## PLANNING AND ZONING BOARD STAFF REPORT

### Kia Delray

Meeting	File No.	Application Type
October 20, 2025	2024-259-SPR-LV3	Level 4 Site Plan Modification, with 2 Waivers
Property Owner	Authorized Agent	
Myers Auto Group DK LLC	Mike Troxell, Thomas Engineering

Figure 3.20 – Setbacks for Buildings over 300' wide on East side of Federal Highway

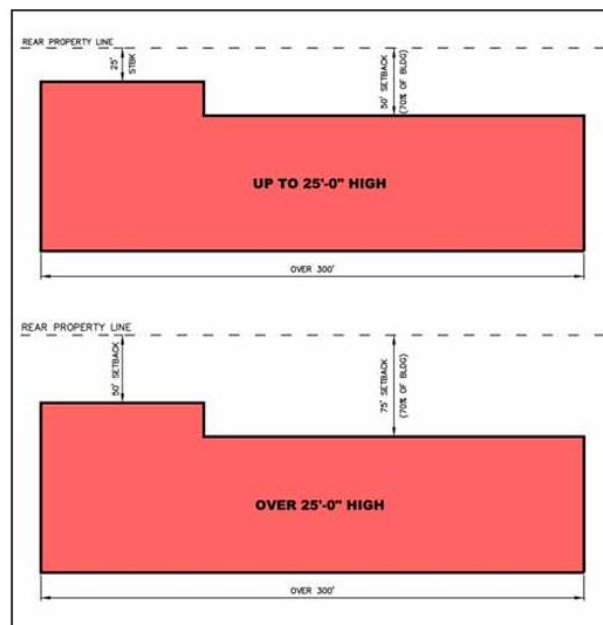
The structure is greater than 25 feet in height, so the minimum building setback is 50 feet and at least 70% of the building must meet a minimum setback of 75 feet. The proposal rear minimum setback is 60.17 feet, specifically where the stairwells extend, and majority of the building is setback 68.25 feet. The residential neighborhood to the rear is separated with a 50-foot public right-of-way.

The Board must consider if the proposed setback and the adjacent public right-of-way is adequate distance from the adjacent residential properties, and if the minimal projections and recessions are sufficient to reduce the massive scale and uniform appearance of the large parking garage structure.

Figure 3.21 – Landscape Buffer Detail - Commercial Property separated from Residential by Street or Alley

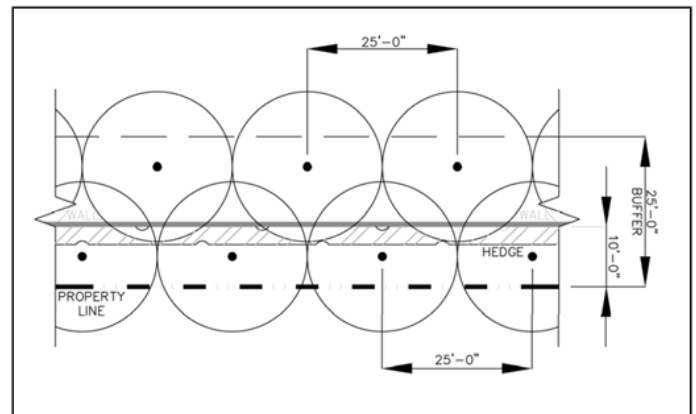
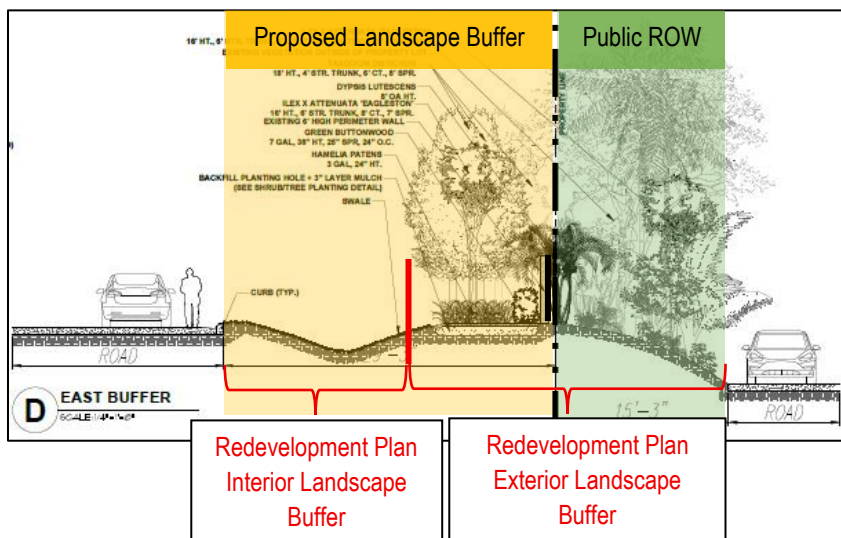
This buffer standard applies specifically to residential properties separated by a street or ally; therefore, the Redevelopment Plan intention is to buffer the residential properties with 10 feet of landscaping plus the separation from the public right-of way including any existing landscape, resulting in a more robust buffer. The project proposes new trees west of the property line with 25-foot spacing, as well as additional trees within the public right-of-way to comply with the 25-foot spacing.

The applicant does not intend to comply with this recommended landscape standard in the Redevelopment Plan, and is requesting relief from LDR Section 4.6.5(F) to maintain an existing wall on the property line instead of the required 2-foot setback (image at right). Further analysis of the wall setback relief is provided in this report.

While the proposed landscape plan includes new trees and utilizes existing vegetation within the public right-of-way, the overall buffering treatment along the eastern edge requires careful consideration. The Redevelopment Plan envisions a stronger landscaped transition to preserve the comfort and privacy of adjacent residential areas. Ensuring an appropriate balance between functional site design and neighborhood sensitivity will be essential to maintaining the character and long-term stability of the corridor. The Board must consider if utilizing solely the public right-of-way landscaping is sufficient buffering for the adjacent residential community and whether the combination of on-site and right-of-way landscaping achieves this balance and remains consistent with the intent of the South Federal Highway Redevelopment Plan.

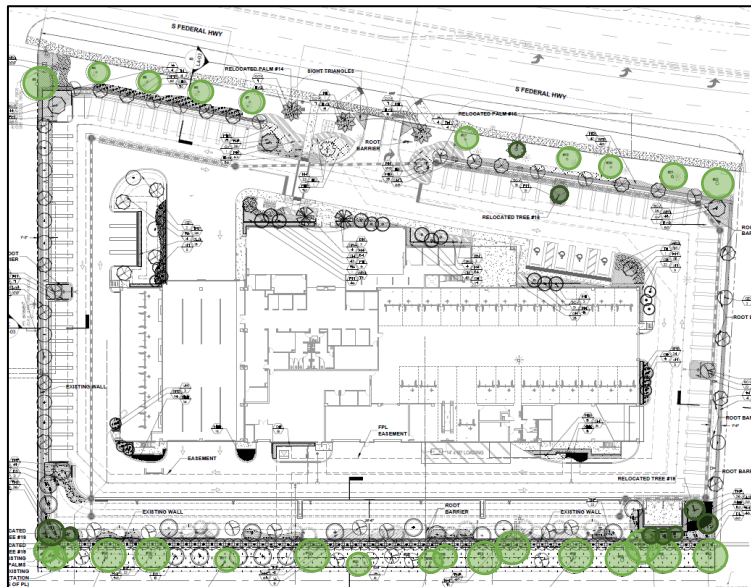
The proposal includes the removal of three Christmas Palms, a Carrotwood (invasive tree, not counted toward mitigation), and a Royal Palm; the removed trees meet the mitigation standards pursuant to LDR Section 4.6.19, with replacement on a one-to-one basis for the four palms. The proposal will preserve 24 trees (shown in light green, at right), and relocate nine trees on site (shown in dark green, at right). The full arborist report is attached.

The proposal also includes new trees, shrubs and groundcovers along the building and the north and south property lines. The perimeter and interior landscaping, including but not limited to landscape islands, special landscape setback, tree and shrub species and height, groundcover, and open space, have been reviewed and are deemed compliance to LDR Section 4.6.16. The proposed landscape buffer to the rear is in compliance to LDR Section 4.6.16(H)(3)(d), and a 25-foot buffer is provided; however, the location and design of the buffer does not align with the Redevelopment Plan, as discussed earlier. The Board must determine if compliance with the LDR Landscaping is sufficient or if a rearrangement of the buffer aligning with the Redevelopment Plan is necessary.
